From: Bull, Trishah <Trishah.Bull@kingcounty.gov>
Sent: Monday, January 30, 2017 10:32 AM
To: marywictor@comcast.net; Mike Ammerlaan
Cc: Lindsey Ozbolt
Subject: RE: Public Comment (0)--KC Trail ELST Segment 2B--SSDP2016-00415 Fwd3: Access to Beach Rights easement R.M. Kantonen

Dear Trishah Bull / King County, & cc: Lindsey Ozbolt / Associate Planner at the City of Sammamish for Public Comment on K.C. Trail - ELST

RE: Opposition to King County's Proposed 60% Plans Segment B

Alternative 2c, Keysto[illegible] Century wall, natural stone and weathered rock face.

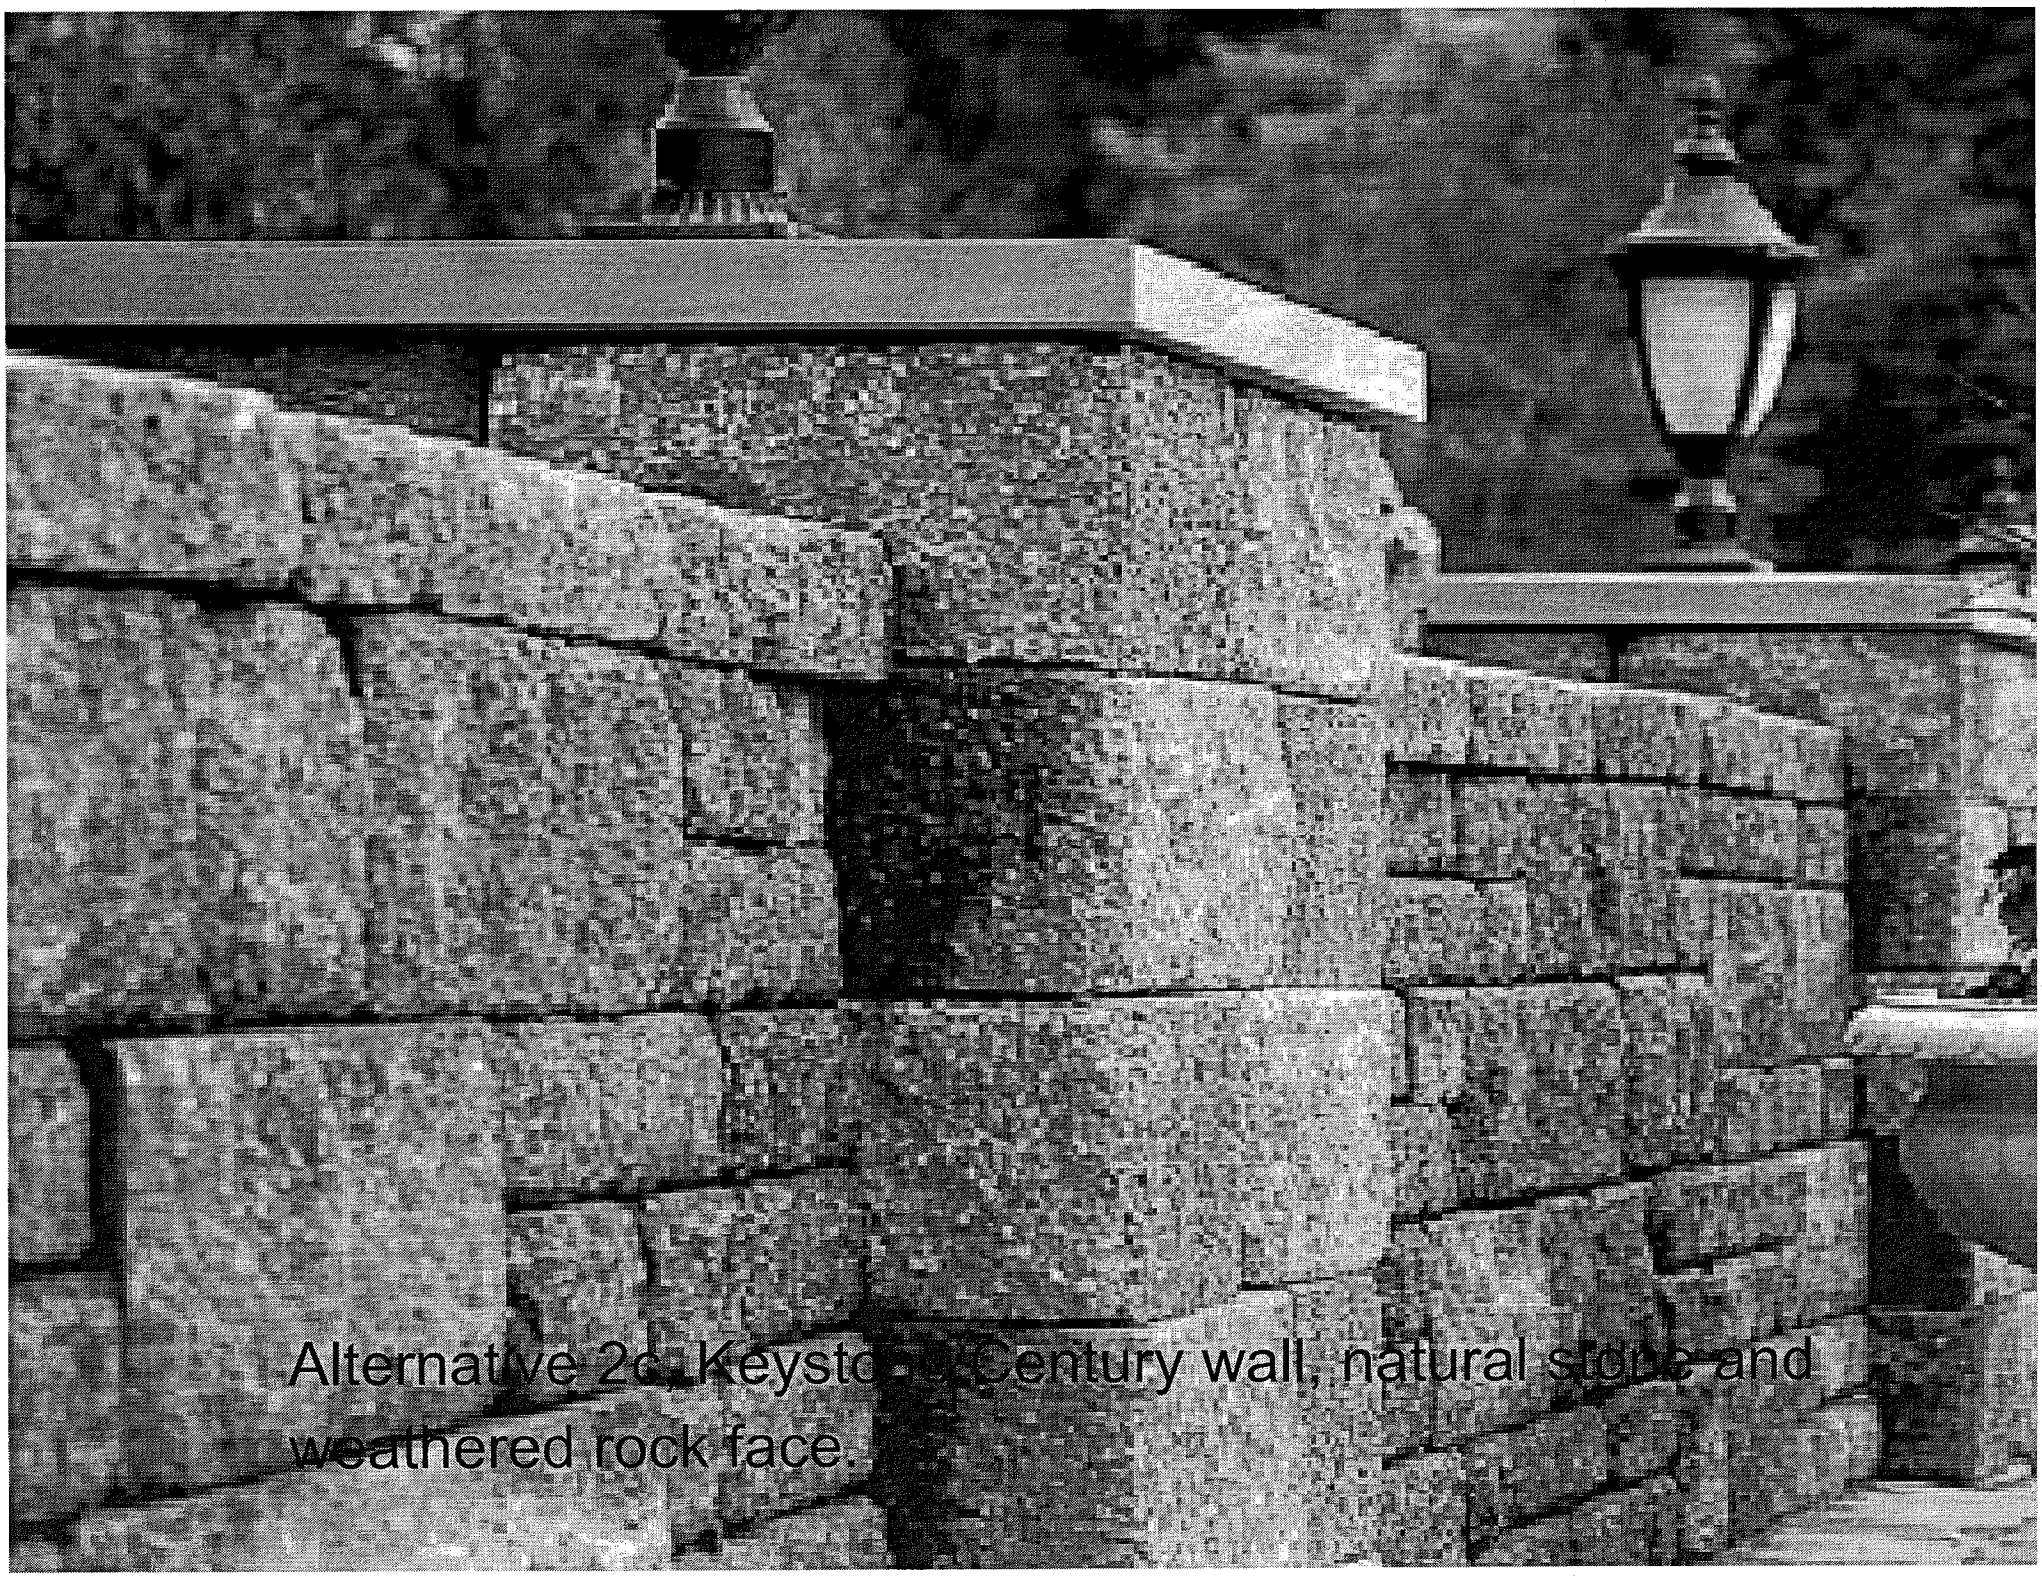
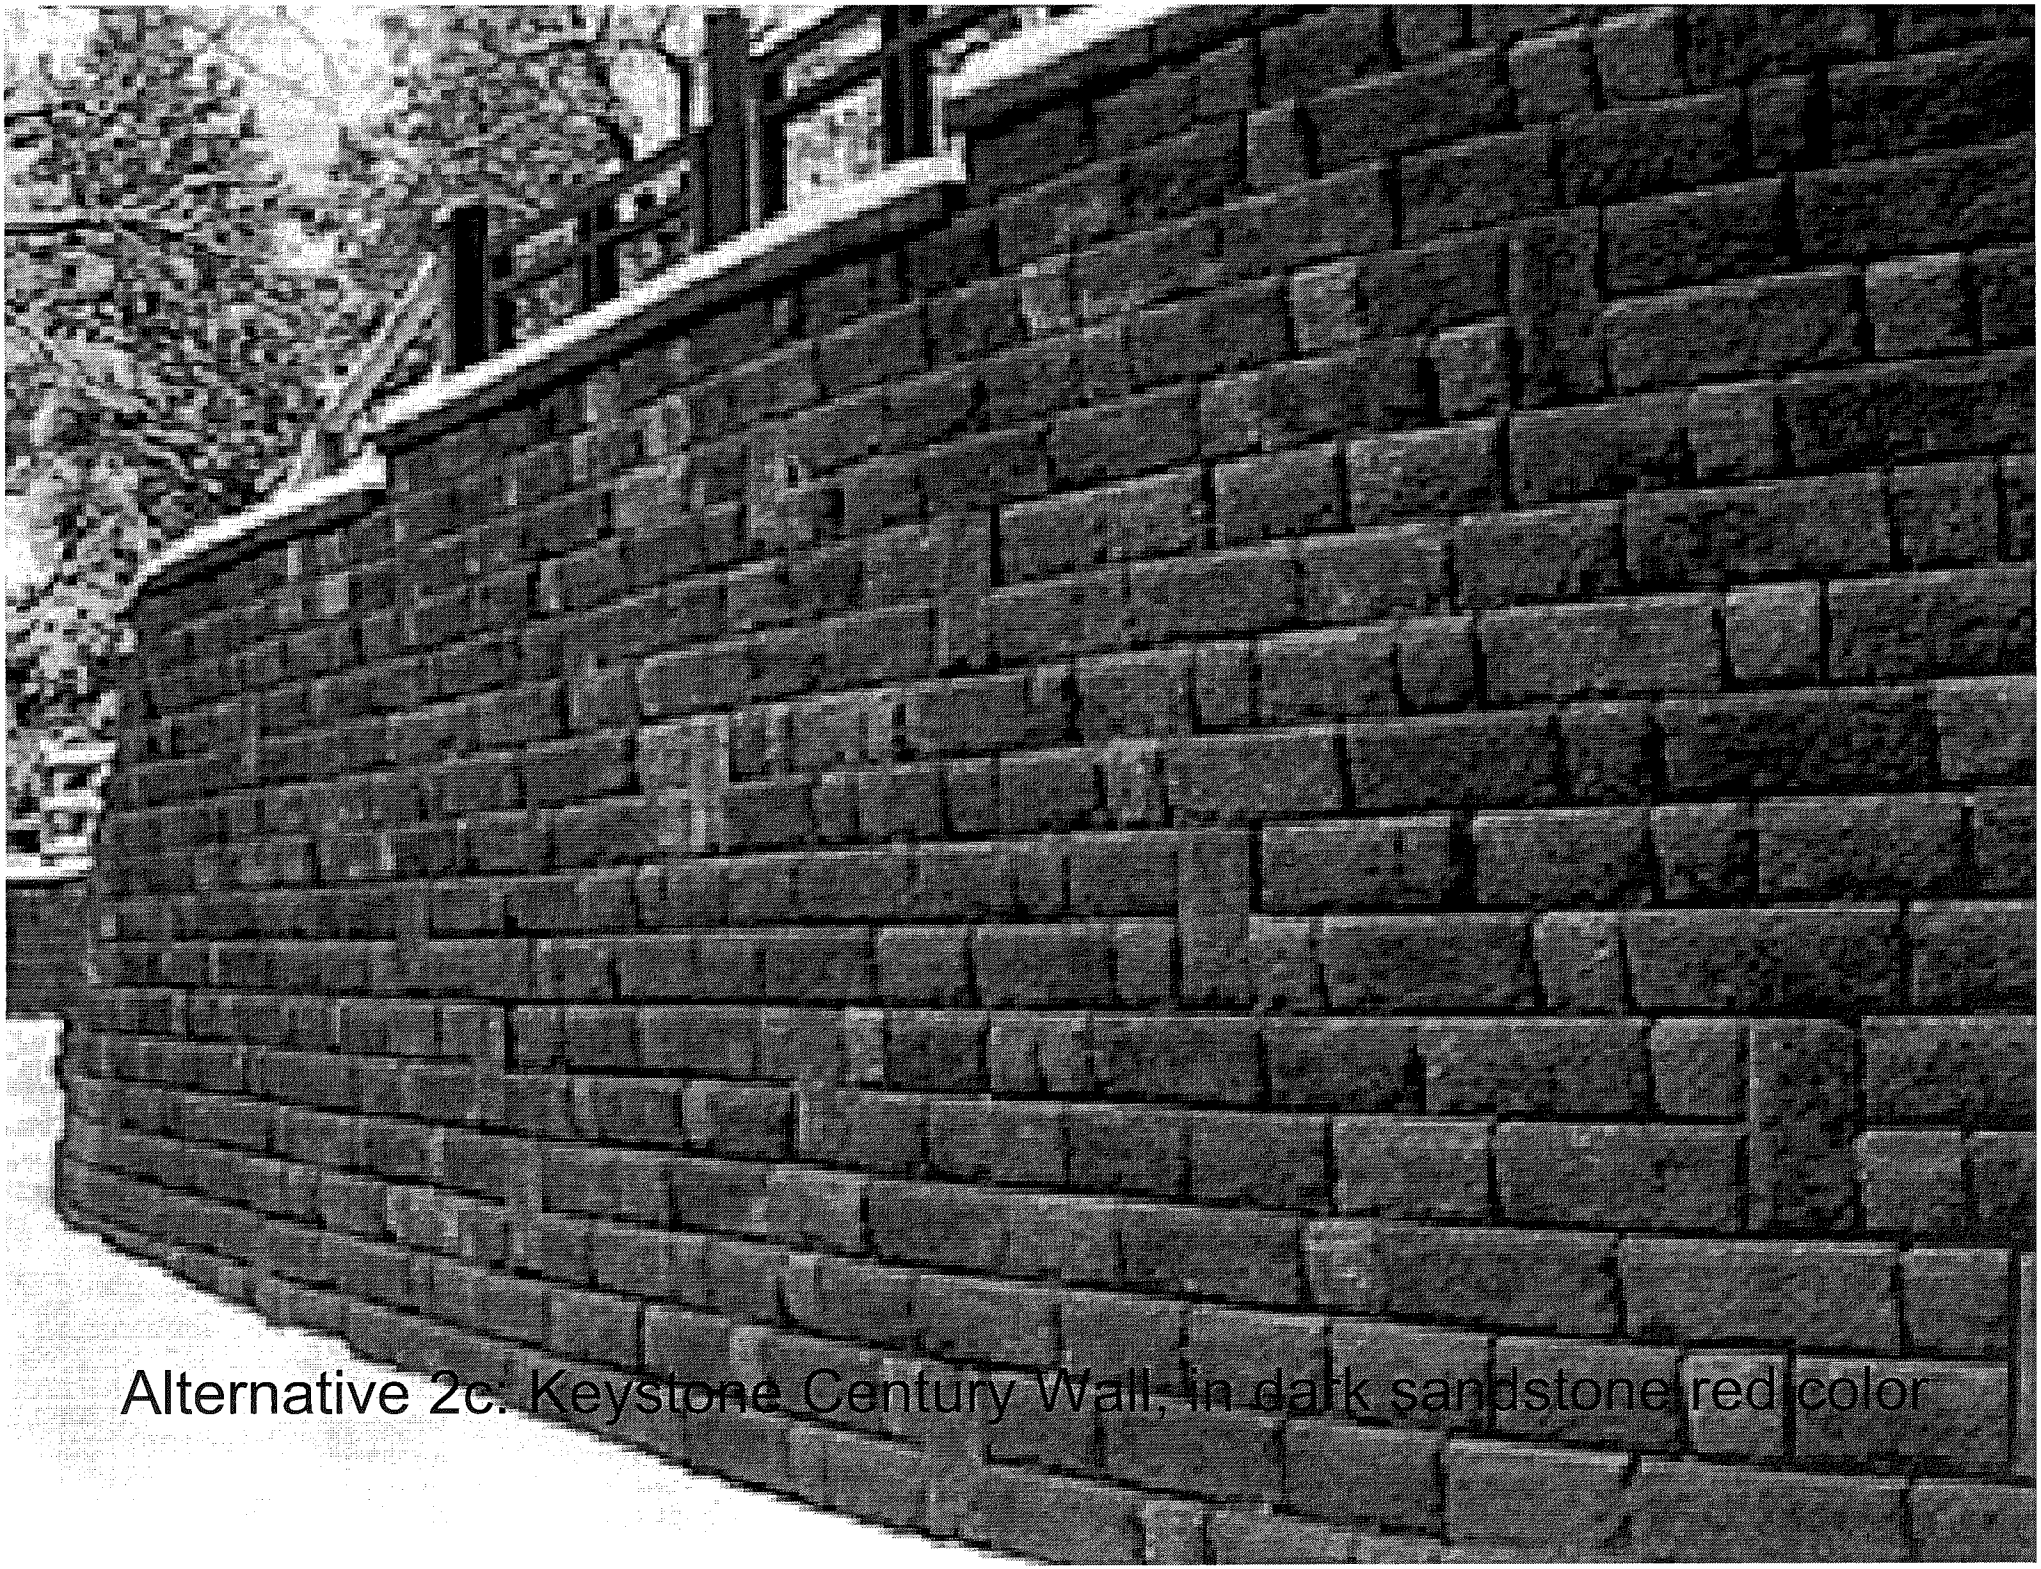
6. Chapman Wall: The County agrees to construct the proposed County wall in front of the Chapman residence (Wall 13A on plan sheet AL 10) on the same alignment as the wall in the existing construction plans for the adjoining property to the immediate south (Wall 13 on plan sheet AL 10). The County agrees to temporarily remove the driveway retaining wall constructed by Chapman. Chapman shall obtain three competitive bids from licensed and bonded contractors for rebuilding the wall. Chapman shall either accept the lowest bid, or if a higher bid is accepted, Chapman must agree to pay out-of-pocket the different between the higher bid and the lowest bid. The County agrees to pay Chapman a sum equal to the lowest bid, with the County's obligation capped at a maximum of $7,500, to compensate Chapman for the costs of rebuilding the wall following construction of the North Sammamish segment of the ELST. Payment shall be received by counsel for Chapman within 45 days of the County's receipt of the competitive bids. With respect to construction of the County's proposed retaining wall adjacent to the Chapman residence, the County shall give Chapman the option of choosing one of the styles/designs attached as **Exhibit 2**.
